## HISTORIC AND DESIGN REVIEW COMMISSION

**HDRC CASE NO:** 2019-145  
**ADDRESS:** 815 E ASHBY PLACE  
825 E ASHBY PLACE  
835 E ASHBY PLACE  
837 E ASHBY PLACE  
841 E ASHBY PLACE  
875 E ASHBY PLACE  
**LEGAL DESCRIPTION:** NCB 3053 BLK LOT 11, 12, 13 & 14 (4.635 AC) & P-100 (0.142 AC) & P-101 (0.3304 AC) TOTAL: 5.1074 AC  
**ZONING:** I-1, RIO-2  
**CITY COUNCIL DIST.:** 1  
**APPLICANT:** Ashley Farrimond/Kaufman & Killen, Inc., Embrey Partners, Ltd., AREA Real Estate, LLC, Humphreys & Partners Architects, L.P.  
**OWNER:** SSGT Borden Park LLC  
**TYPE OF WORK:** Construction of a 5-story, multi-residential structure, rehabilitation of an existing structure  
**APPLICATION RECEIVED:** March 18, 2019  
**60-DAY REVIEW:** May 17, 2019  
**CASE MANAGER:** Edward Hall  
**REQUEST:**

The applicant is requesting conceptual approval to:

1. Perform rehabilitative scopes of work to the Borden Building, the existing structure located at 875 E Ashby Place. Existing rear additions may be removed.
2. Construct a five-story, multi-family residential structure on the lots addressed as 815, 825, 835, 827 and 841 E Ashby Place.
3. Perform river beautification improvements, trail improvement

**HDRC Application – 815 E. Ashby  
Embrey Partners, Ltd. & AREA Real Estate LLC**

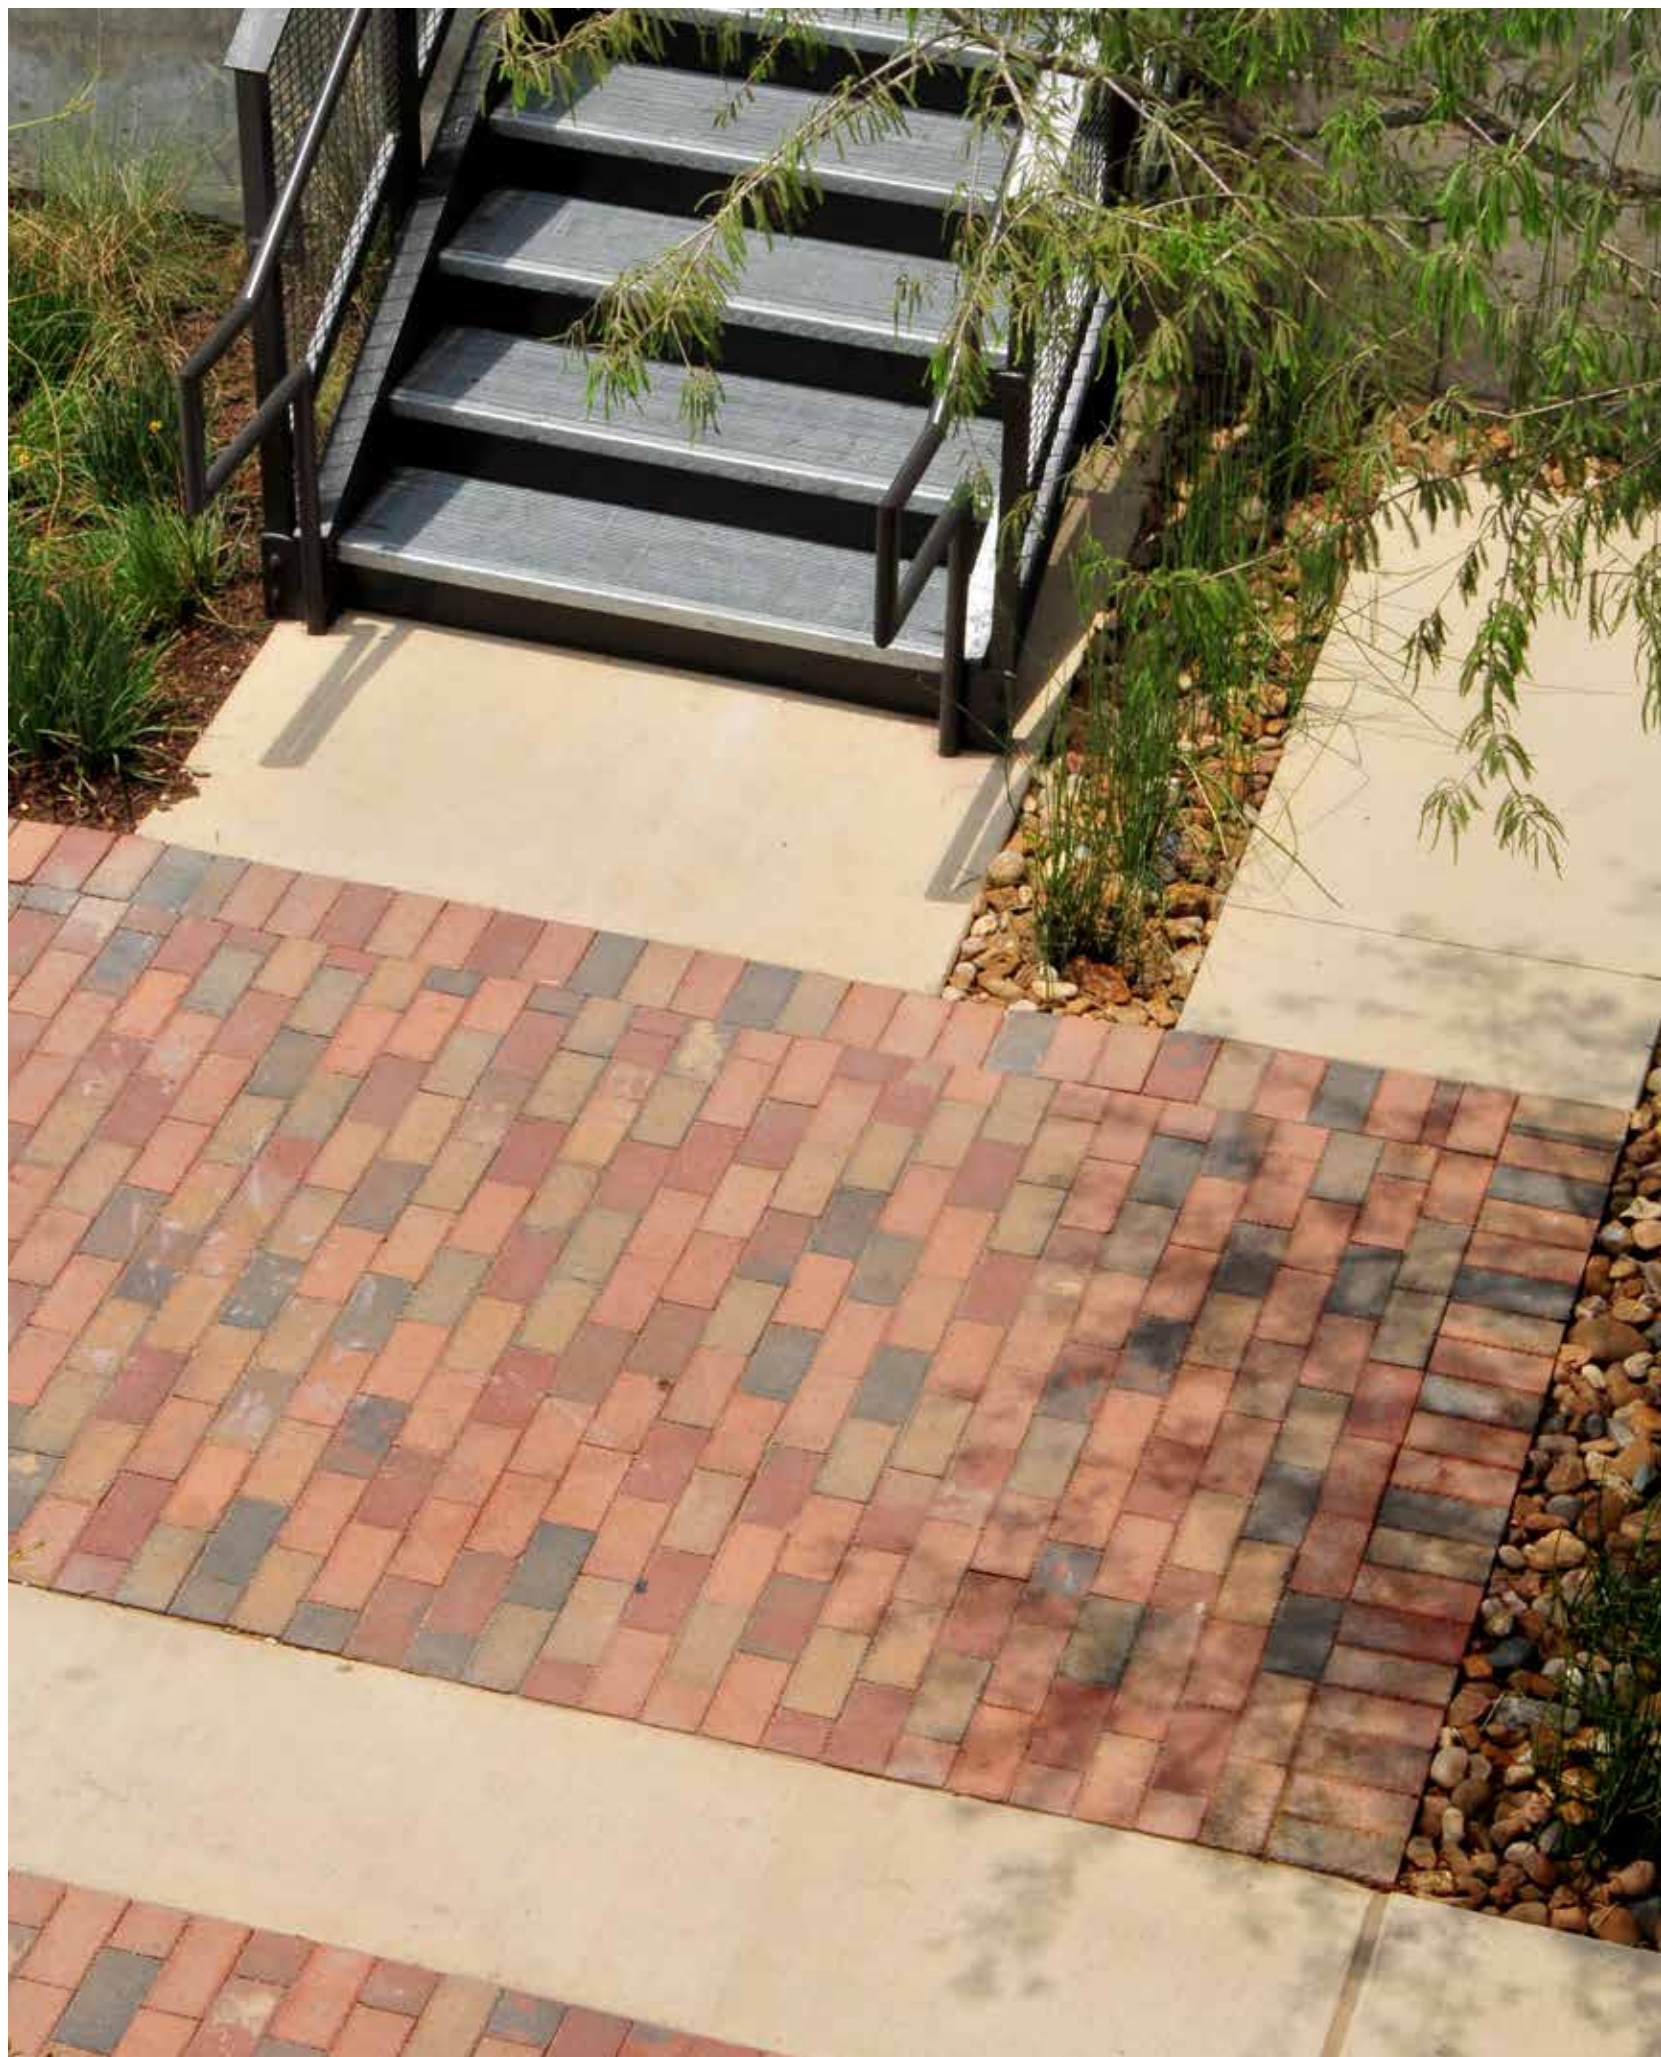
area users, provide pedestrian connections between sites, help animate the street scene and define street edges. Primary entrances should be oriented toward the street and shall be distinguishable by an architectural feature. The applicant has proposed to site the new construction adjacent to the right of way at E Ashby. Additionally, the applicant has proposed to remove the existing site paving that extends River Road into the site, adjacent to the San Antonio River. Staff finds the proposed site design to be appropriate and consistent with the UDC.

- 2f. LANDSCAPE DESIGN – The applicant has provided landscaping information on the conceptual site plan. The applicant is responsible for complying with the UDC in regards to landscape design.
